Department of Energy
Field Office, Albuquerque
Los Alamos Area Office
Los Alamos, New Mexico 87544

On September 30, 1993, this office received a Notice of Deficiency (NOD), dated September 28, 1993, for the Resource Conservation and Recovery Act (RCRA) Facility Investigation Work Plan for the Los Alamos National Laboratory Operable Unit 1098, with a list of deficiencies enclosed.

RFI Work Plan for Operable Unit (OU) 1098

Figure 7.5-1 Proposed SWMU no. 2-004, storage pits and tanks of the Omega West Reactor, RFI boring-soil sampling locations.

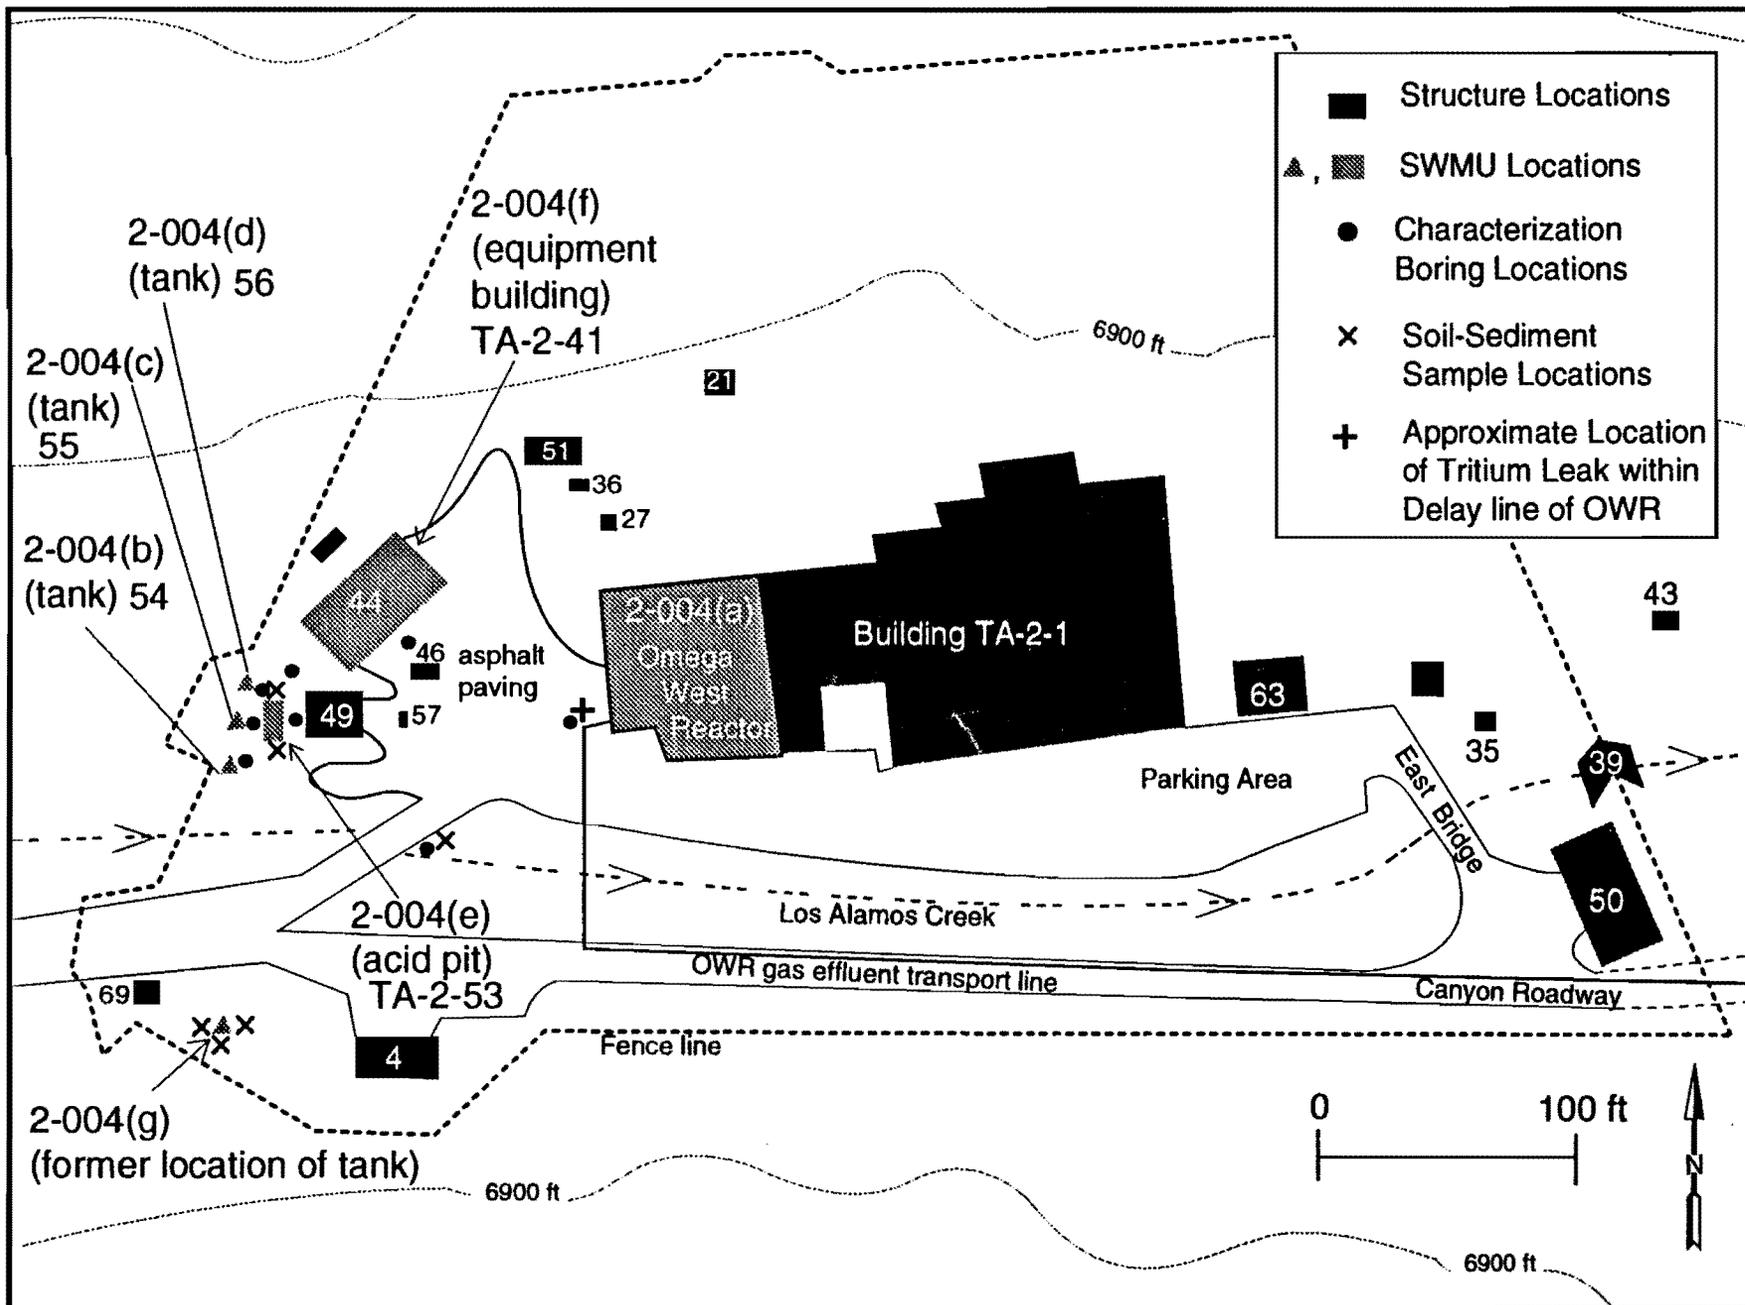
Comment 2. "7.5.3.2 Surface Sampling, p. 7.5-6 and 7.5.3.3 Subsurface Sampling, p. 7.5-7 -

b. If spills were common around the acid pit then more than 2 samples may be appropriate, and the subsurface borehole should probably be slanted under the pit."

Comment 2b, A total of five boreholes and two surface samples will be taken immediately adjacent to SWMU 2-004 (e) as shown in the revised Figure 7.5-1 (attached). The figure has been changed to label SWMU 2-004(e) as the Acid Pit. The number of samples proposed is judged to be appropriate to address the goal of confirming the presence or absence of contamination associated with this SWMU. If contaminants are confirmed, additional sampling will likely be appropriate in follow up characterization work. The two borings closest to SWMU 2-004(e) (North and South) will be slant-drilled in order to obtain samples from directly beneath the acid pit.

Figure 7.15-1 Proposed SWMU no. 41-002, sewage treatment plant, RFI boring-soil sampling locations.

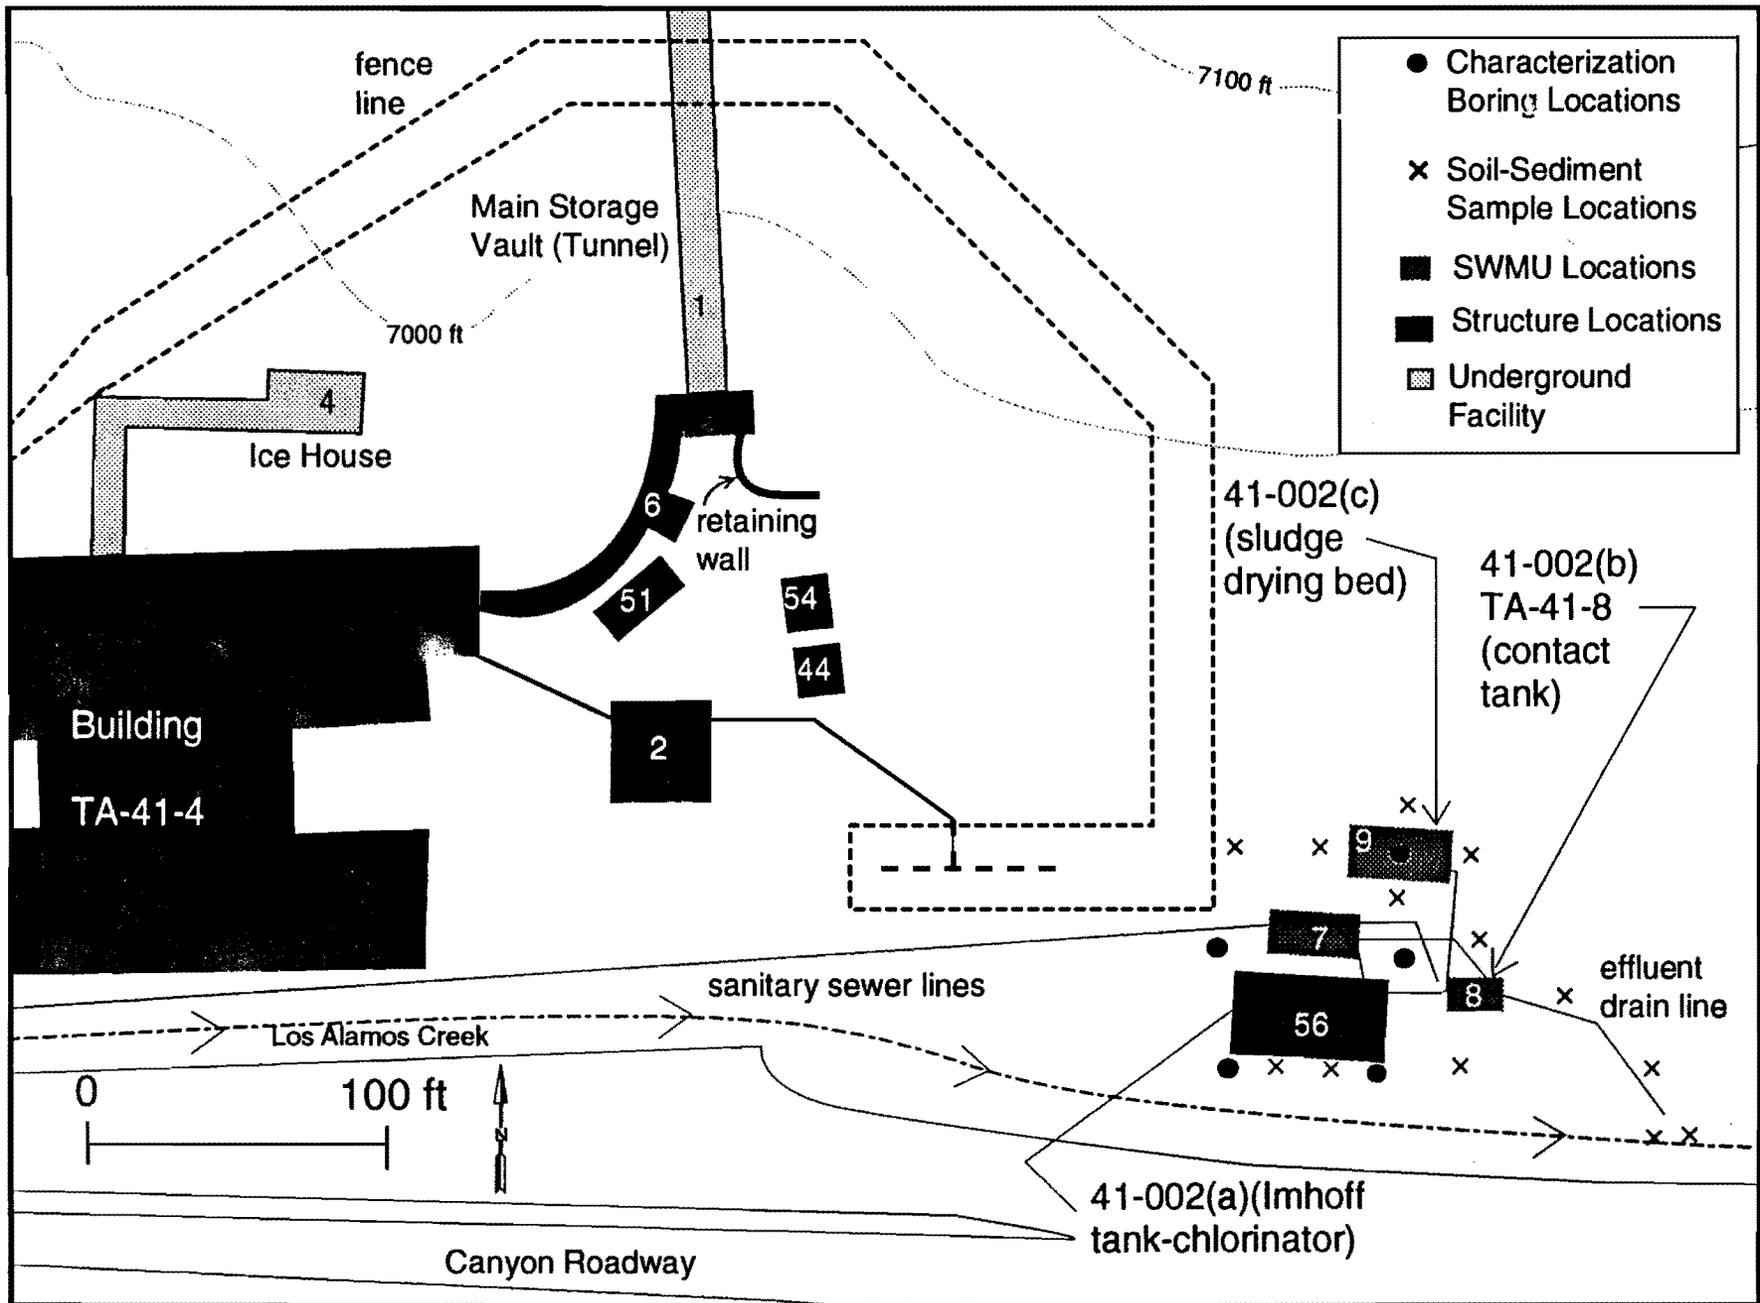
Comment 5. "7.15.3.2 Subsurface Sampling, p. 7.15-5 - Borings should be placed as close to SWMU 41-002(a) as possible, or angled under the tank to investigate for potential contamination."

Response: Boreholes will be placed as close to SWMU 41-002(a) as possible assuming that no radiological anomalies are found. If anomalies are found, then borehole locations will be adjusted in order to investigate the anomalies. Given that alluvial ground water exists at shallow subsurface depths of less than 20 feet with ground water flow velocities on the order of 1200 feet per year, and that contamination, if present, is likely to have spread due to interaction with this ground water, angled boreholes are not judged to be necessary for a phase I investigation that is only designed to confirm the presence or absence of contamination.

Figure 7.16-1 Proposed SWMU no. 41-003, sump, RFI soil sampling locations.

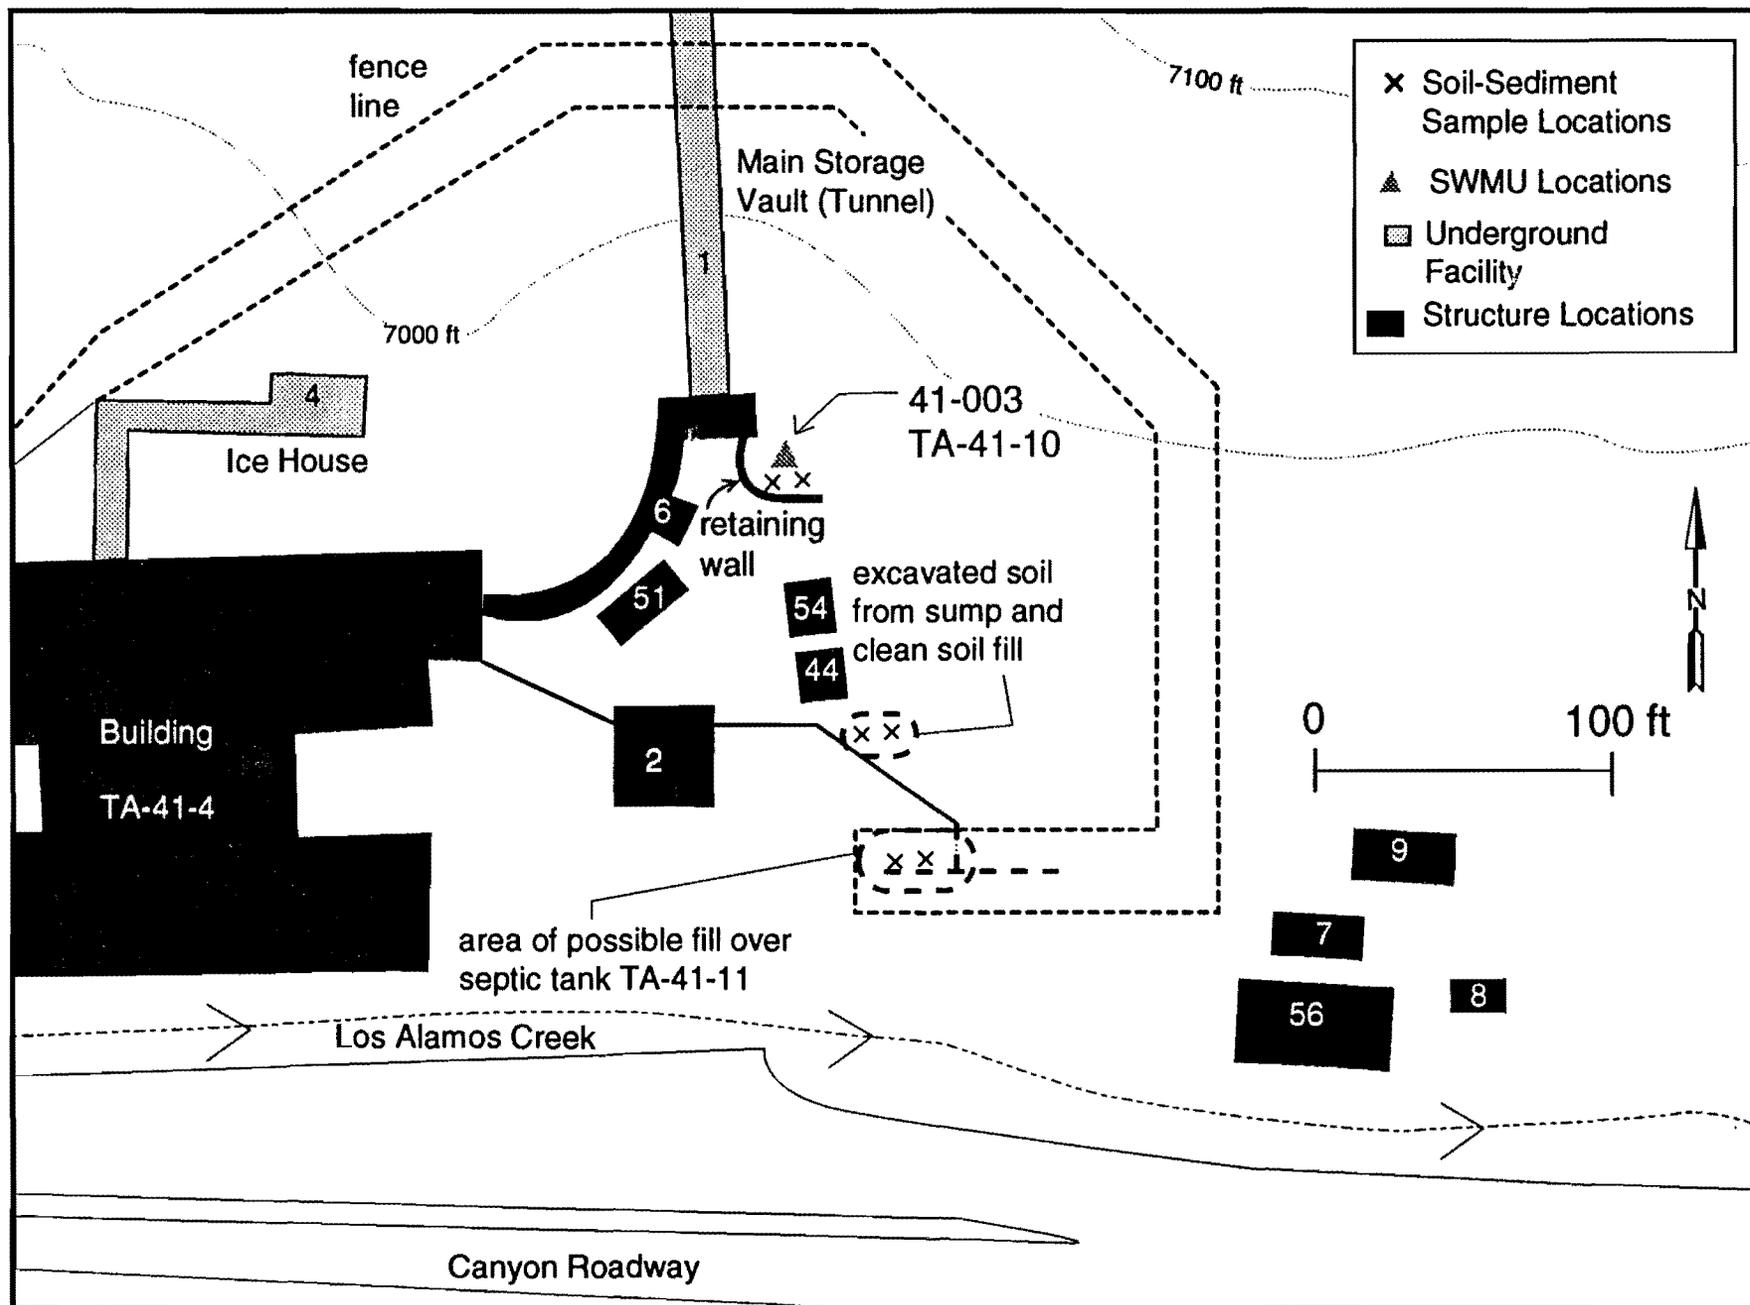
Comment 6. "7.16.3.2 Surface Sampling, p. 7.16-4 - Two of the samples collected from the area where the sump is located should be collected at a depth of 2-4 feet."

Response: Because of reconstruction of the area where the sump was located, the sump area is now covered by approximately 4 feet of fill material. If the intent of the comment is to assure that samples are obtained from a depth of 2 to 4 feet beneath the level of the ground surface where the

sump was formerly located, then boreholes would need to reach a depth of approximately 6 to 8 feet beneath the level of the present ground surface. The 2 soil samples that are to be taken at the location of the former sump are indicated on the unrevised figure 7.16-1 (attached). These soil samples will be sampled from depths of 6 to 8 feet.

Figure 7.16-1 Proposed SWMU no. 41-003, sump, RFI soil sampling locations.

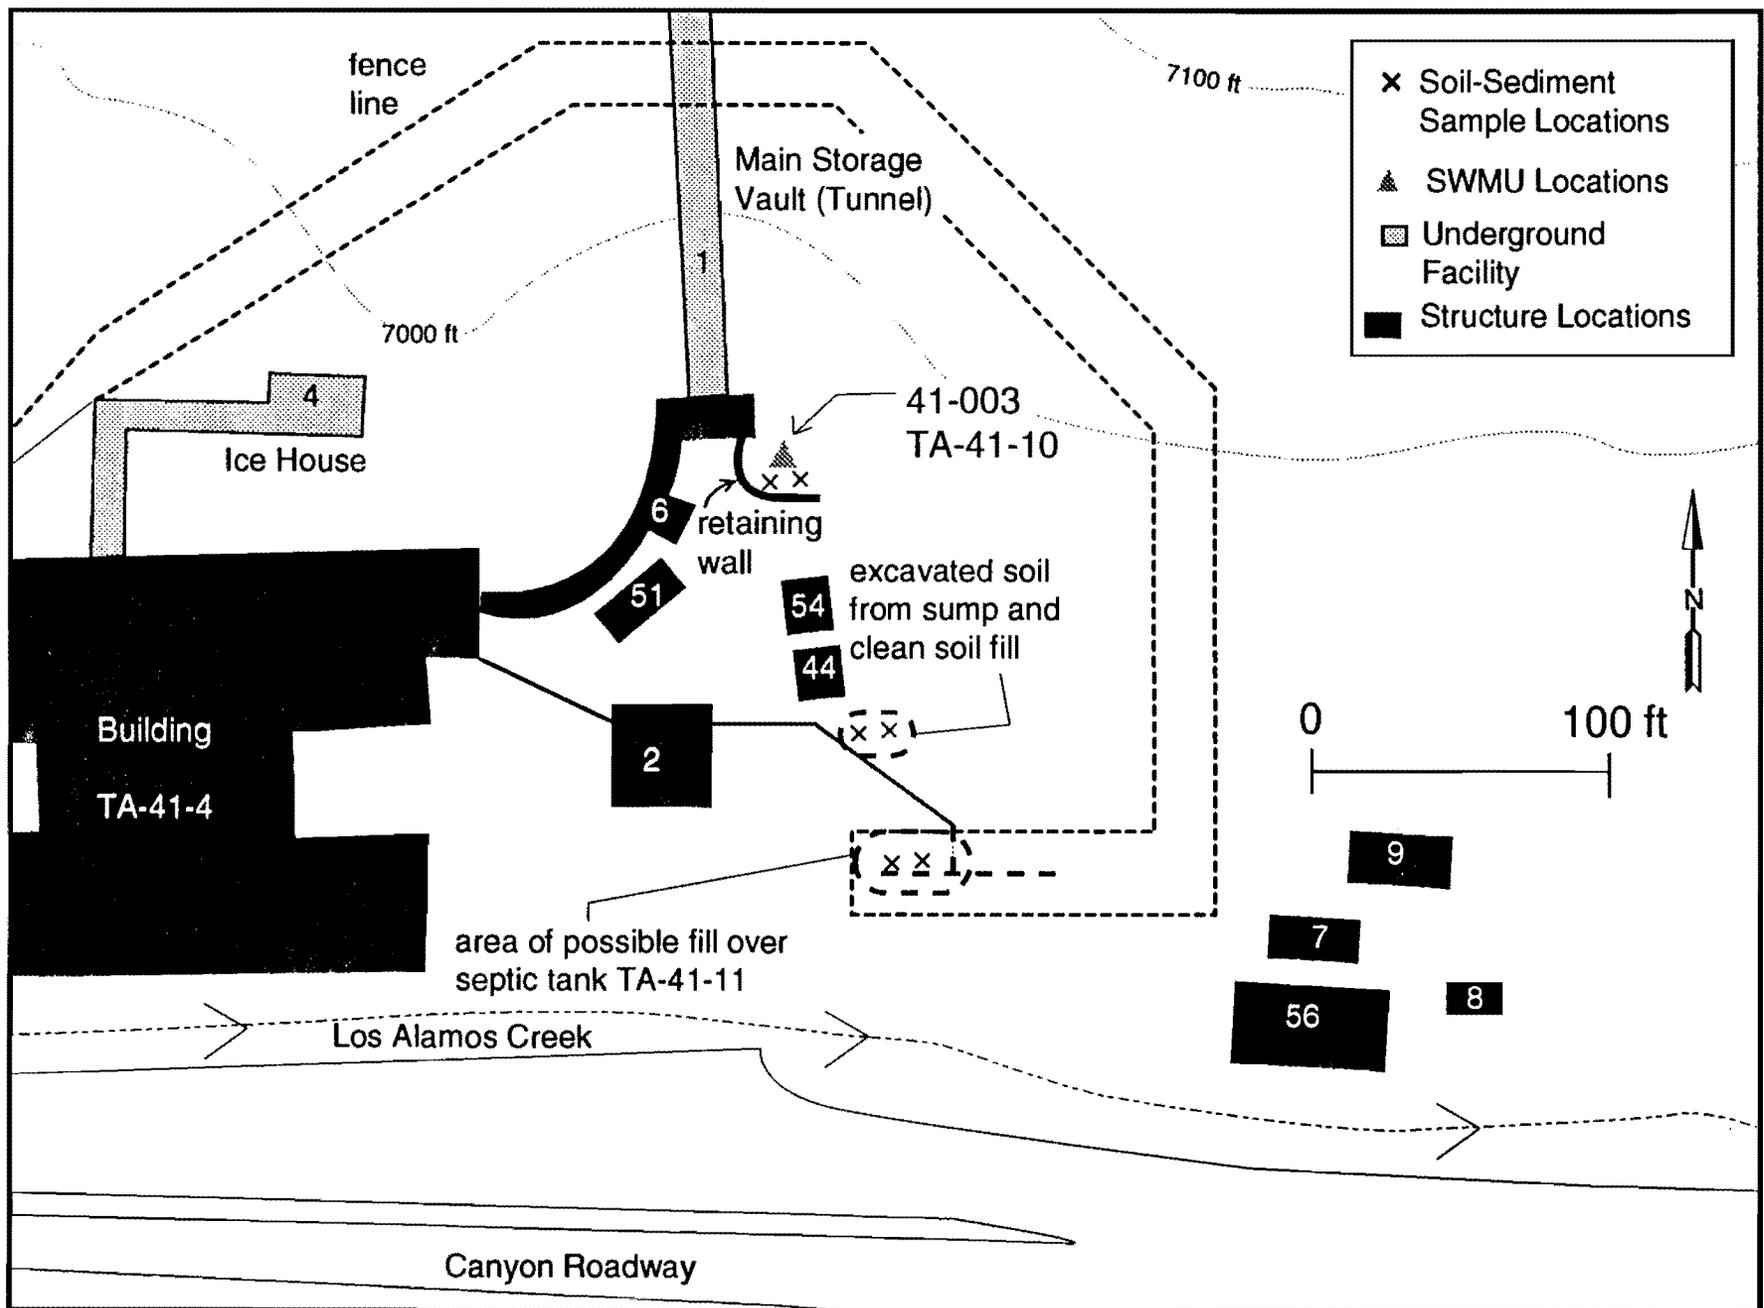
Comment 6. "7.16.3.2 Surface Sampling, p. 7.16-4 - Two of the samples collected from the area where the sump is located should be collected at a depth of 2-4 feet."

Response: Because of reconstruction of the area where the sump was located, the sump area is now covered by approximately 4 feet of fill material. If the intent of the comment is to assure that samples are obtained from a depth of 2 to 4 feet beneath the level of the ground surface where the

sump was formerly located, then boreholes would need to reach a depth of approximately 6 to 8 feet beneath the level of the present ground surface. The 2 soil samples that are to be taken at the location of the former sump are indicated on the unrevised figure 7.16-1 (attached). These soil samples will be sampled from depths of 6 to 8 feet.
